UNITED STATES PATENT AND TRADEMARK OFFICE

APPLICATION NO.	FILING DATE	FIRST NAMED INVENTOR	ATTORNEY DOCKET NO.	CONFIRMATION NO.
09/745,074	12/20/2000	Nobuyuki Itoh	55506(840)	9273

Office Action Summary

DETAILED ACTION

FIG. 27

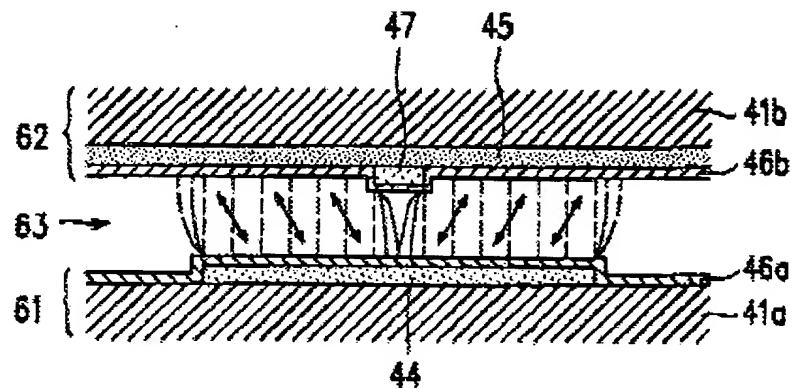
one of the at least one volume excluding member is provided on the at least one electrode on at least one of the pair of substrates, the volume excluding member being provided so as to be on at least a portion of one side edge of the at least one electrode (dashed rectangles in Figure 26); and the liquid crystal molecules are tilted in a uniform direction from the at least one side edge of the at least one electrode to an opposite edge when a voltage is applied to the at least one electrode (per double-headed arrows in Figures 22 and 27, col. 19, lines 9-19).

Hirata discloses zero tilt angle (col. 19, lines 1-8), which is parallel alignment that implies positive dielectric anisotropy, given the molecular alignments indicated in Figures 22 and 27.

FIG. 26

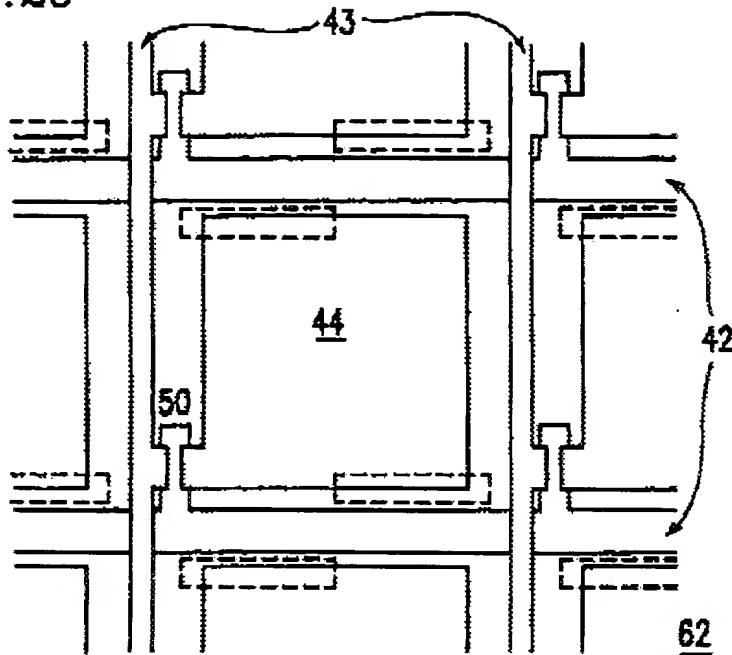
As to claim 4, Hirata in view of Colgan disclose the liquid crystal display as comprised above wherein: a plurality of volume excluding members provided on the at least one electrode on at least one of the pair of substrates, each of the plurality of volume excluding members being provided so as to be on at least a portion of each of an opposing pair of side edges of the at least one electrode but so as not to oppose each other (per dashed rectangles, Figure 26).

As to claim 5, Hirata in view of Colgan disclose the liquid crystal display as comprised above wherein: the at least one electrode on the at least one of the pair of substrates includes a first side edge and a second side edge; and the plurality of volume excluding members are provided along a portion of the first side edge and along a portion of the second side edge (per Figure 26).

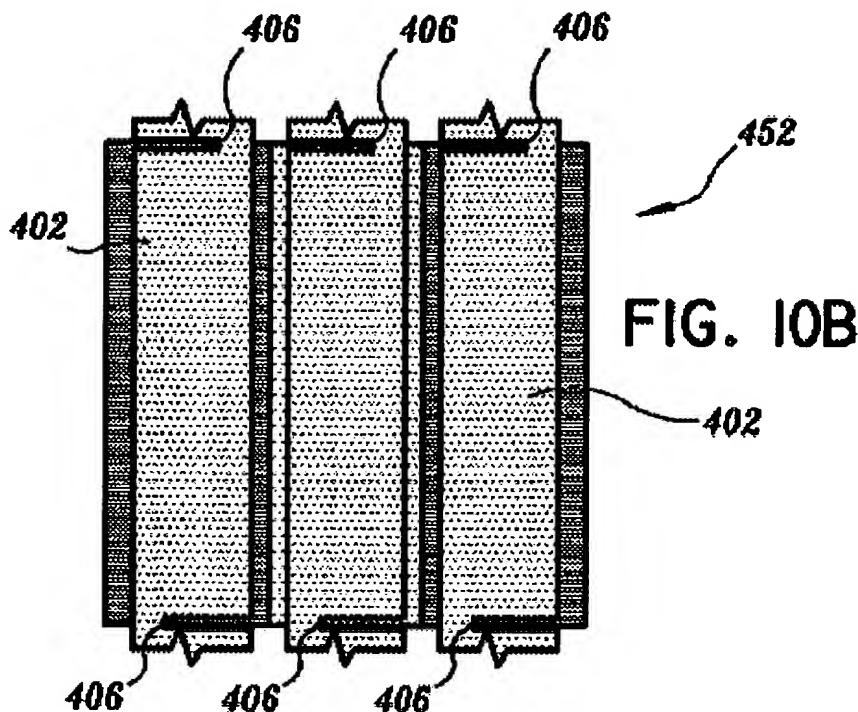
Colgan teaches the use of homeotropic alignment (Applicant's vertical alignment treatments) (col. 9, lines 50-55) and liquid crystal material with negative dielectric anisotropy (col. 7, lines 33-38) in a display with gaps, notches, or ridges, 406 (col. 12, lines 38-47), to comprise a display with an improved wide viewing angle (Abstract).

FIG. 25

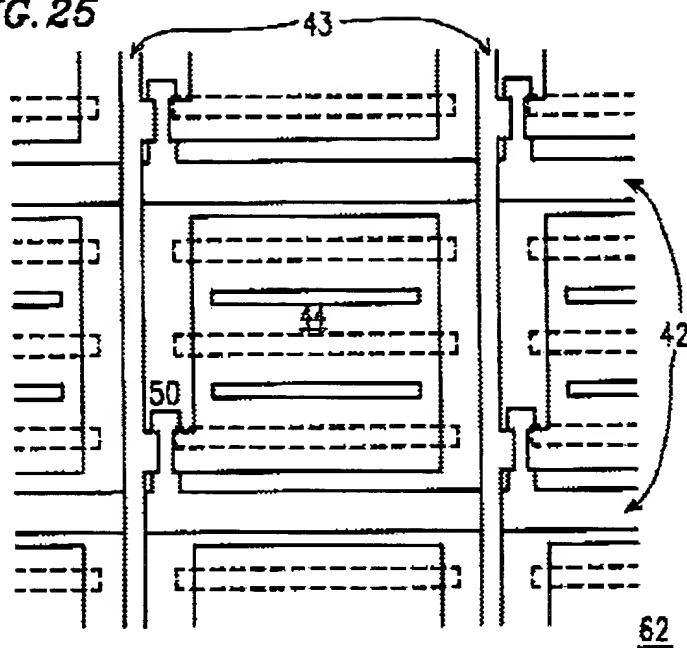
As to claim 6, Hirata in view of Colgan disclose the liquid crystal display as comprised above wherein: slit-like openings (Applicant's non-conductive window portion) (solid rectangles in pixel region of Figure 25) is formed in the at least one electrode on the at least one of the pair of substrates (col. 21, lines 27-32).

Hirata teaches the window openings may be interchanged with the volume excluding members (col. 21, lines 28-32). Hirata teaches that the addition of more pixel dividing members (adding more volume excluding members or non-conductive windows) provides a more natural looking effect to the eye of the observer (better picture).

FIG. 11(a)

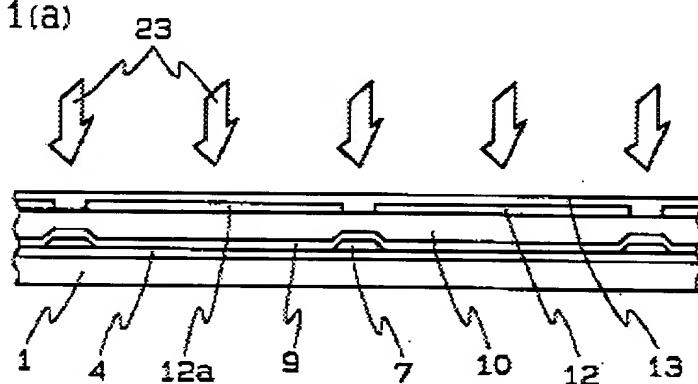
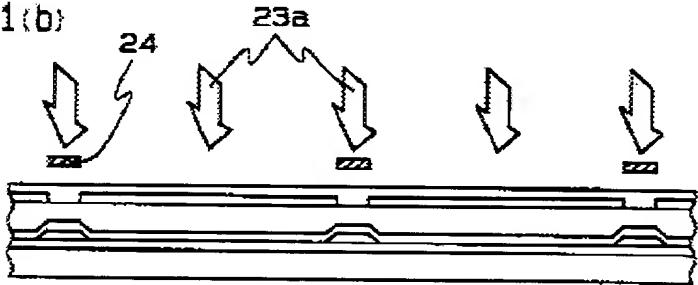
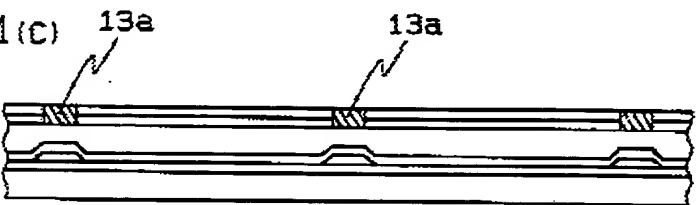
Numano teaches in Embodiment 3 (col. 11, line 35 through col. 12, line 5) and Figures 11(a)-11(c) the use of polarized ultraviolet light to weaken the strength of the alignment layer (reducing the vertical alignment to become more horizontal in alignment) in the region between pixels to reduce cross talk and allow for a higher

aperture ratio (col. 12, lines 3-5). The teachings and motivation of Numano expressed in 10 embodiments are considered to be robust to suggest the claimed invention to those having ordinary skill in the art of liquid crystals. Also, providing a direction of the horizontal alignment of the liquid crystal molecules in the at least one pixel portion is substantially identical to a direction of uniaxial horizontal alignment of the liquid crystal molecules in the non-pixel portion would be obvious to those having ordinary skill in the art of liquid crystals to prevent light leaks and thereby improve contrast.
